SUBJECT: ADDENDUM #1

Date: October 27, 2026

Project: Site Work, Restroom & Fire Alarm Upgrades at Quail Valley Middle School
Snowline Joint Unified School District
FFJ Project No: SJ21-01
DSA File No.: 36-73 DSA Appl. No: 04-121057

ENLARGED DEMO SITE PLAN - PARKING LOT NORTHWEST OF BUILDING 200

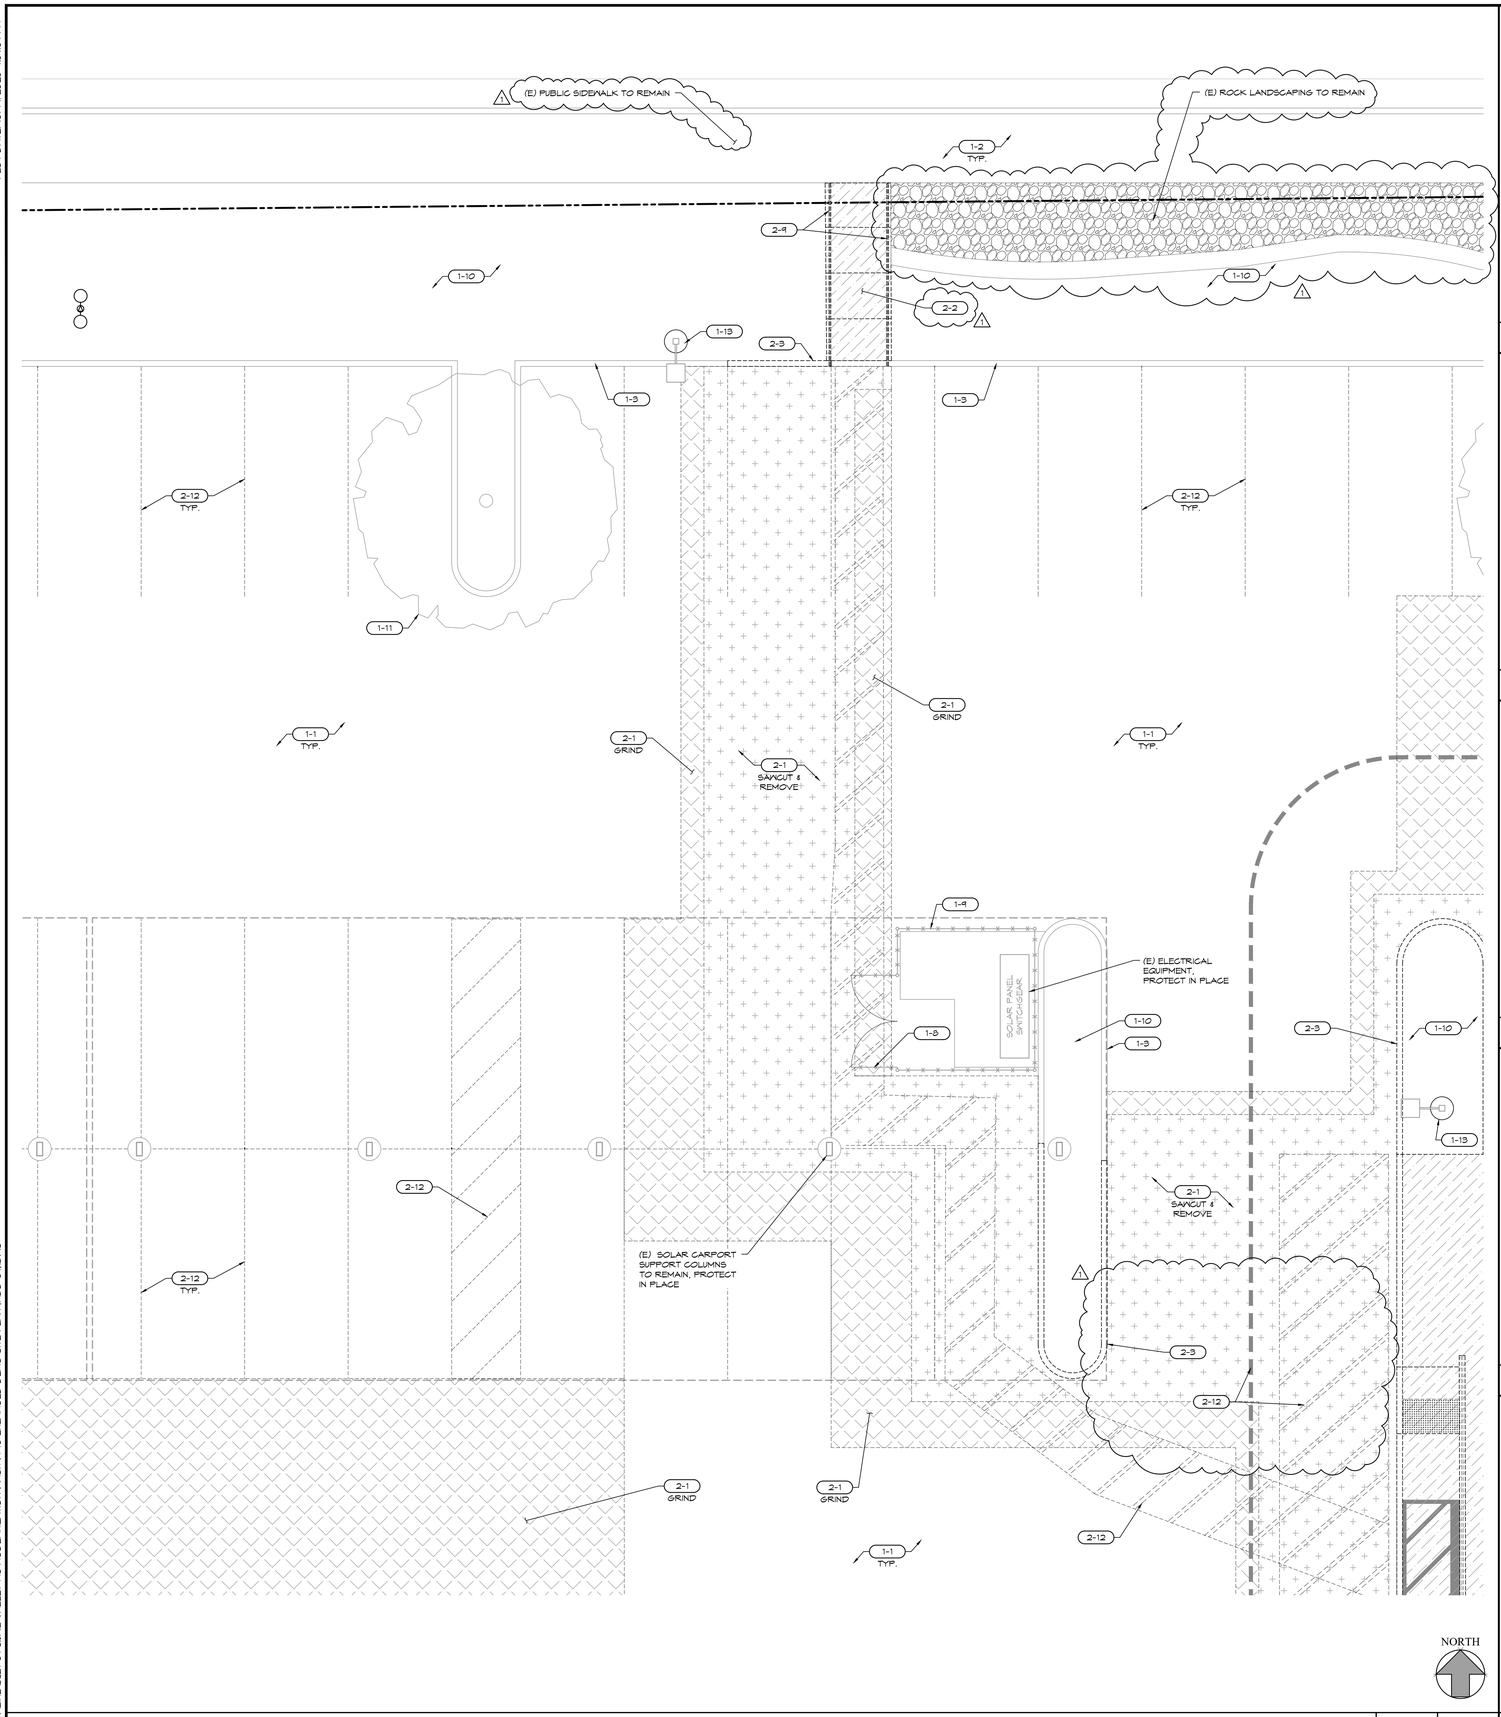
18. Sheet A-10 – ENLARGED DEMO SITE PLAN
a. Updated keynote 1-14, 1-15, 1-17, 2-5 & 2-12 on Site Plan Keynotes.
b. Added keynotes 1-20 to 1-28 & 2-13 to 2-19 on Site Plan Keynotes.
c. Site Plan Legend moved to new location on sheet to make room for keynote changes.
d. Added existing rock landscaping to remain along Yucca Terrace Drive.
e. Existing sidewalk note added.
f. Extended asphalt paving removal West of passenger drop-off being removed.

ENLARGED SITE PLAN AT RAMP — SCALE: 3/16" = 1'-0" — 27

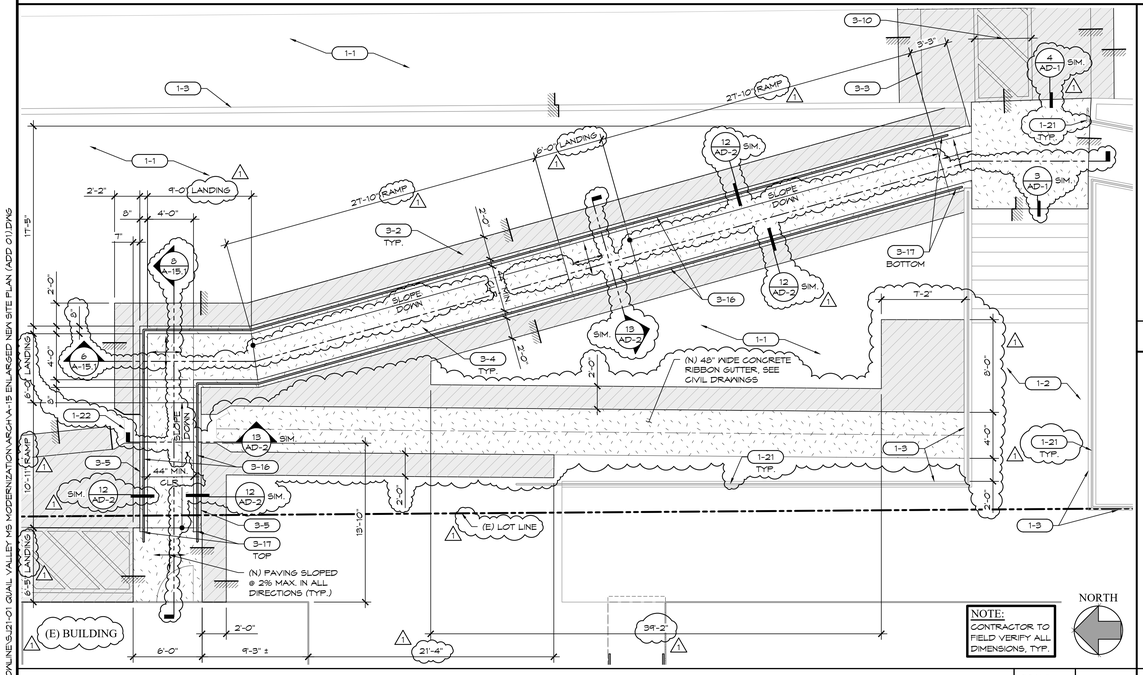
i. Added section and detail callouts to ramp on Detail 27.
j. Identified ramp and landings on Detail 27.
k. Concrete ribbon gutter added to Detail 27.
l. Added dimensions to Detail 27.

SECTION AT RAMP — SCALE: 3/8" = 1'-0" — 6

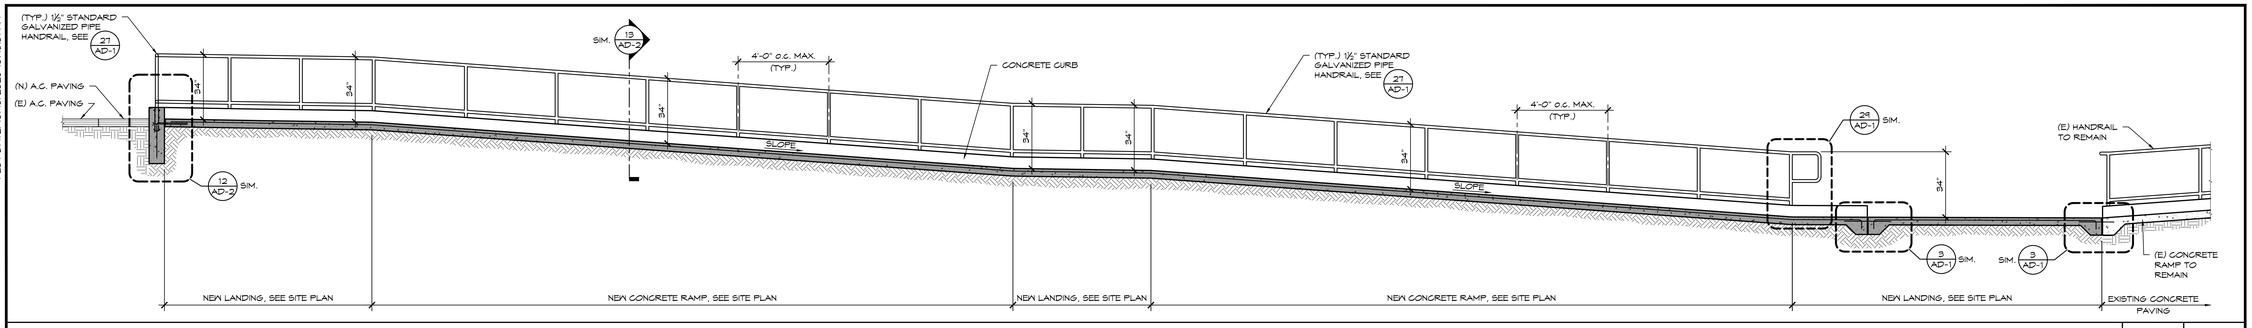
24. Sheet A-15.1 – ENLARGED NEW SITE PLAN & RAMP SECTIONS
a. New sheet added, Detail 6/A-15.1 and Detail 8/A-15.1 were Sections of Ramp in Detail 9 were added to this sheet as they were missing in the approved plans.

BUILDING 200 - OVER ALL FLOOR PLAN

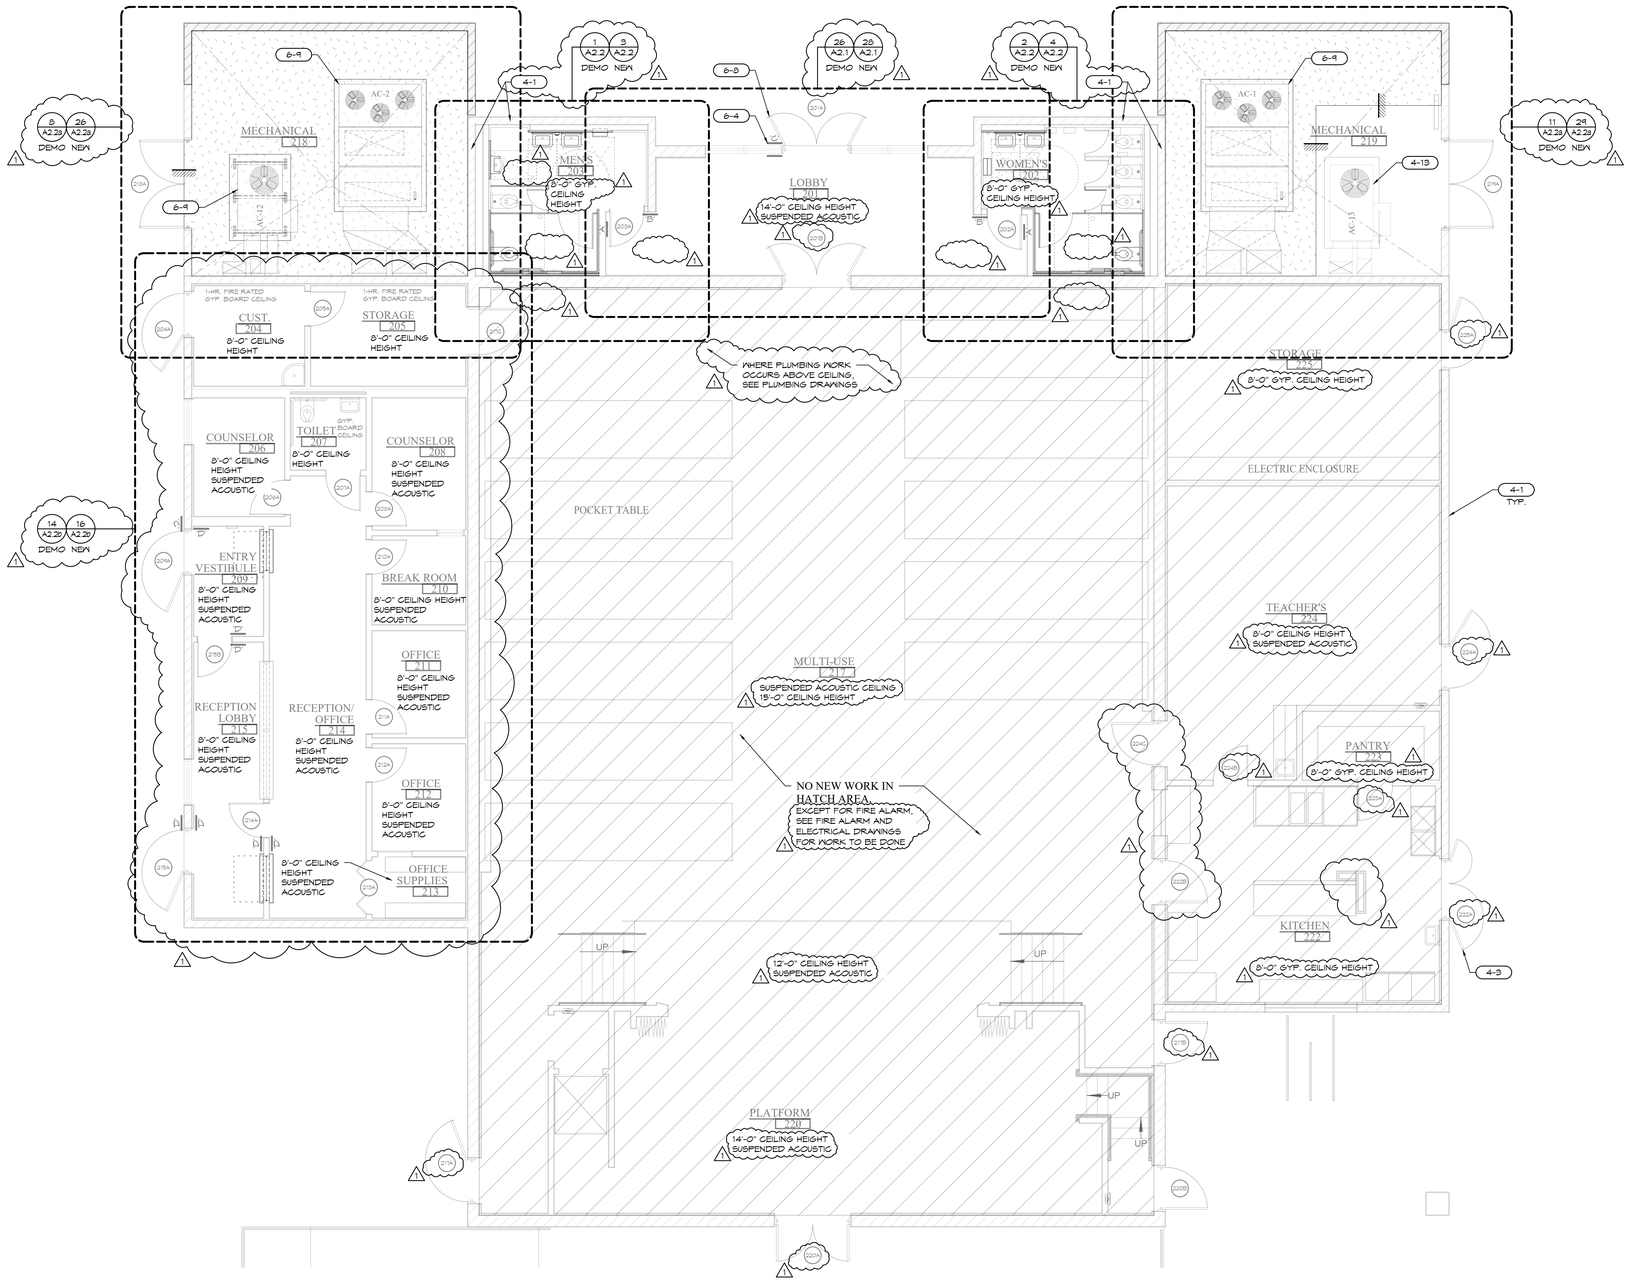
28. Sheet A2.1 – BUILDING 200 – OVERALL FLOOR PLAN
a. Updated keynotes 4-7, 4-8, 4-11, 6-1, 6-2, & 6-6 on Floor Plan Keynotes.
b. Added keynotes 4-16 to 4-21 & 6-11 to 6-13 on Floor Plan Keynotes.

c. Demolition keynotes added.
d. Wall Legend updated.
e. Detail 23:
1. Mechanical Areas, Men's, Women's & Lobby now have separate detail callouts for additional enlarged floor plans to provide clarity to scope of work being done.

BLDG. 200 - MECHANICAL 218 - ENLARGED NEW FLOOR PLAN | SCALE: 3/8" = 1'-0" | 26

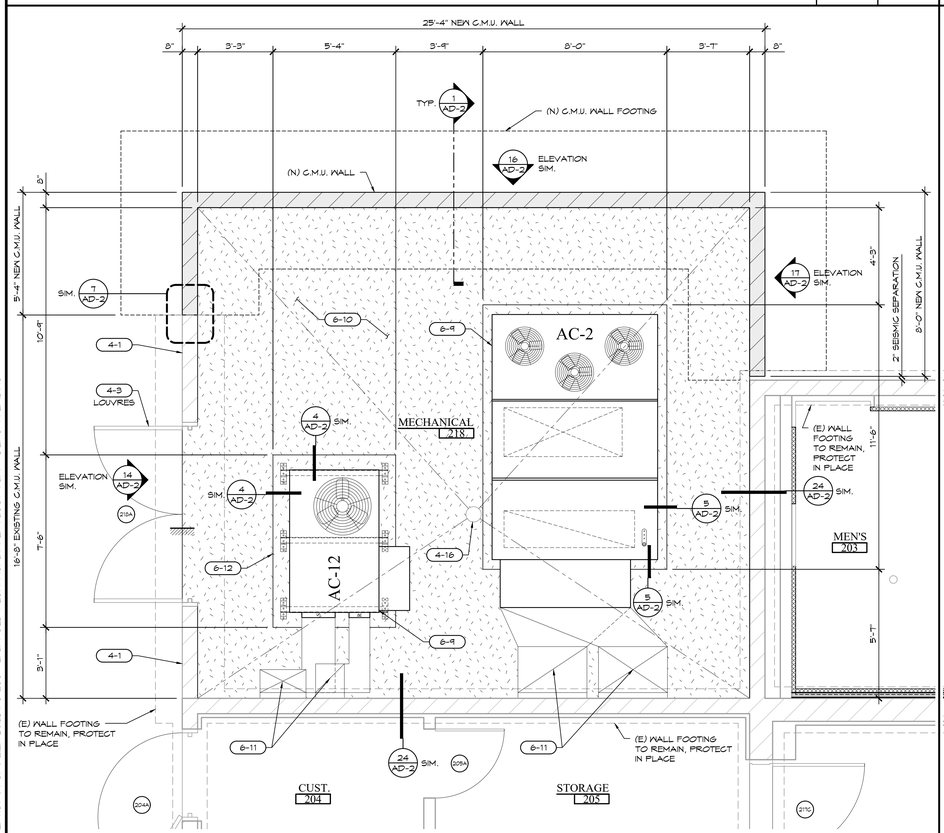
e. Detail 26: Mechanical 218
1. Enlarged New Floor Plan added; this plan is at a larger scale to provide clarity to scope of work.
2. Keynotes added.
3. Added dimensions.
4. Added detail callouts.

BLDG. 200 - MECHANICAL 219 - ENLARGED NEW FLOOR PLAN | SCALE: 3/8" = 1'-0" | 29

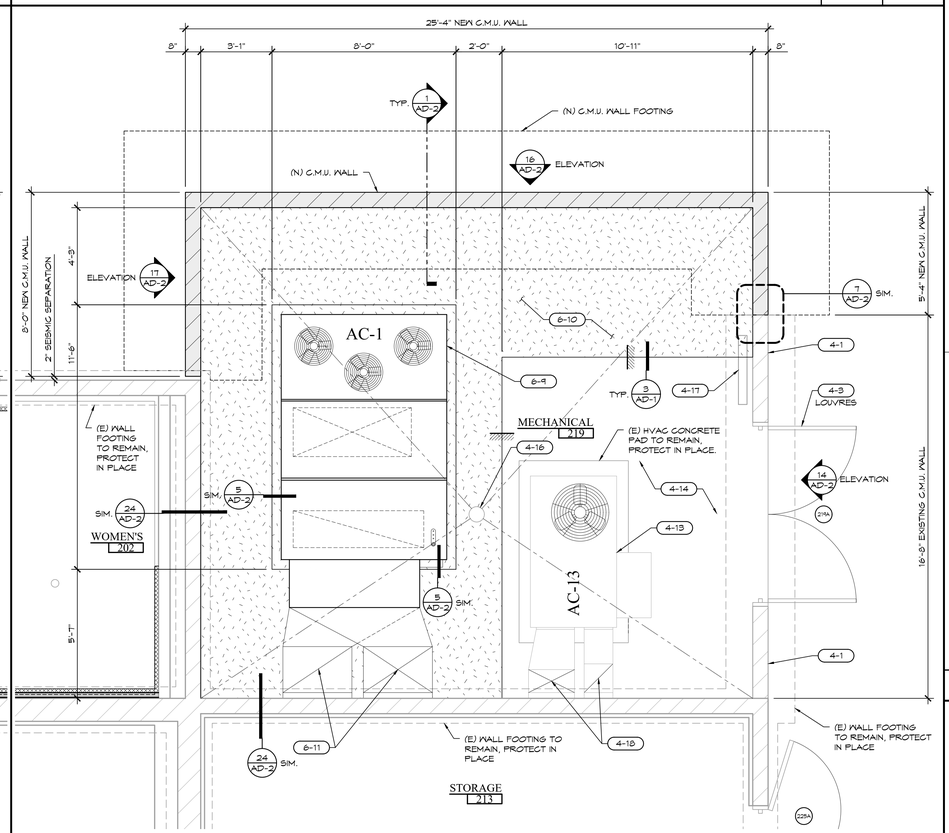
f. Detail 29: Mechanical 219
1. Enlarged Demo Floor Plan added; this plan is at a larger scale to provide clarity to scope of work.
2. Keynotes added.
3. Added dimensions.
4. Added detail callouts.

BUILDING 600 - FLOOR PLAN

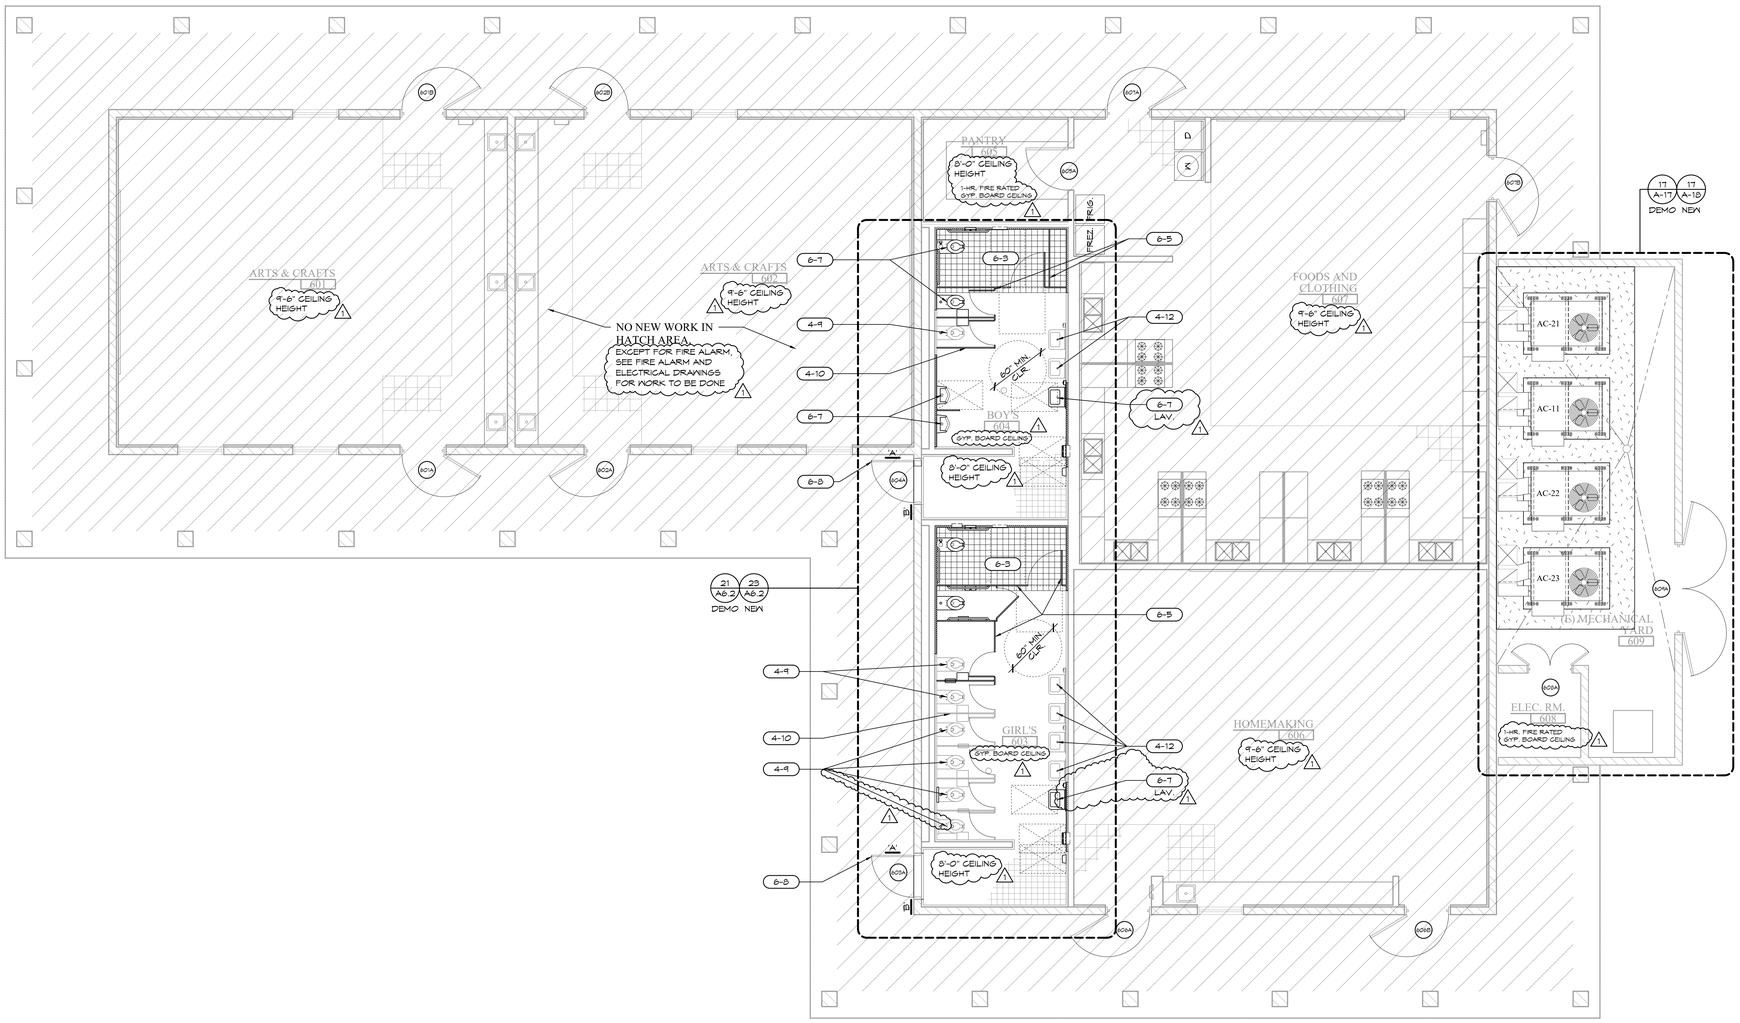
a. Detail 29:
1. Various keynotes not needed removed for clarity.
2. Keynotes added that were missing.
3. Notes added in hatched area "NO NEW WORK" for construction purposes.
4. Ceiling heights added for clarity to scope of work for construction purposes.

ENLARGED FLOOR PLAN - DEMO RESTROOMS | SCALE: ¼" = 1'-0" | 21

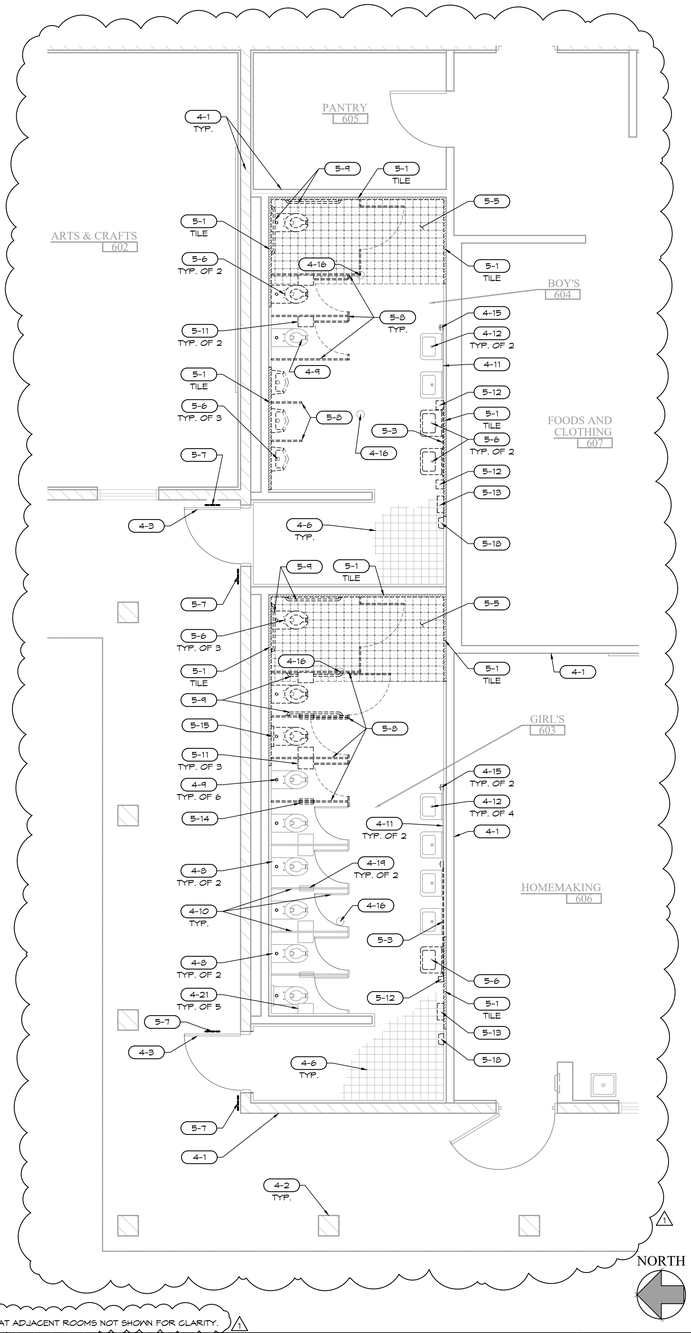
a. Detail 21:
1. Various keynotes for demo and existing added to clarify scope of work to be done.
2. Hatch added to walls where finish to be removed down to bare studs for construction purposes.
3. Note added to detail.
